Access Compliance Report

Public Rights-of-Way

Intersection ID: 22391	Main Street: SHARON_RD	Cross Street: WHISTLESTOP_RD	Location: S
ADA ID: 1918E78731A5	Ramp Type: PerpDiag	Initial Pass/Fail: Fail	Overall Compliance: No
			Severity Score: 33.75

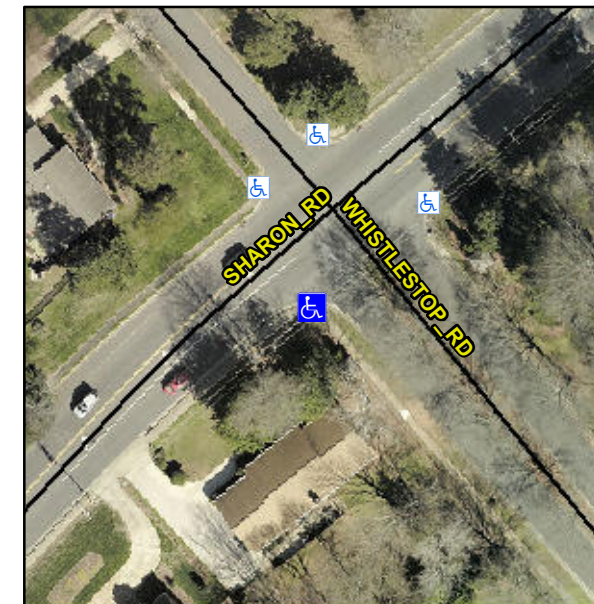
Not Found, R304.5.1, R304.5.3

Compliance	Description	Data	Compliance	Description	Data
N/A	Ramp Length (in)	59.0	Yes	Ramp Slope (%)	5.8
No	Ramp Width (in)	40.0	No	Ramp XSlope (%)	14.7
N/A	Flare Type LT	N/A	N/A	Flare Type RT	N/A
N/A	Flare Slope LT (%)	N/A	N/A	Flare Slope RT (%)	N/A
N/A	Flare Traversable LT?	N/A	N/A	Flare Traversable RT?	N/A
N/A	Landing Length (in)	N/A	N/A	DWS Provided?	N/A
N/A	Landing Width (in)	N/A	N/A	DWS Contrast?	N/A
N/A	Landing Slope (%)	N/A	N/A	DWS Length (in)	N/A
N/A	Landing X Slope (%)	N/A	N/A	DWS Full Width?	N/A
N/A	Landing Curb? (Y/N)	N/A	N/A	DWS Offset (in)	N/A
N/A	Shared Landing?	N/A			
N/A	Gutter Ponding?	N/A	N/A	Gutter Slope (%)	N/A
N/A	Gutter Lip Ht (in)	N/A	N/A	Gutter X Slope (%)	N/A
N/A	Painted X Walk1?	No	N/A	Painted X Walk2?	No
	X Walk 1 Direction	To NE		X Walk 2 Direction	To N
N/A	X Walk 1 Width (in)	N/A	N/A	X Walk 2 Width (in)	N/A
	X Walk 1 Slope (%)	3.9		X Walk 2 Slope (%)	5.7
	X Walk 1 X Slope (%)	6.4		X Walk 2 X Slope (%)	6.9

Remove & Replace Curb Ramp With Two New Directional Ramps or Equivalent.
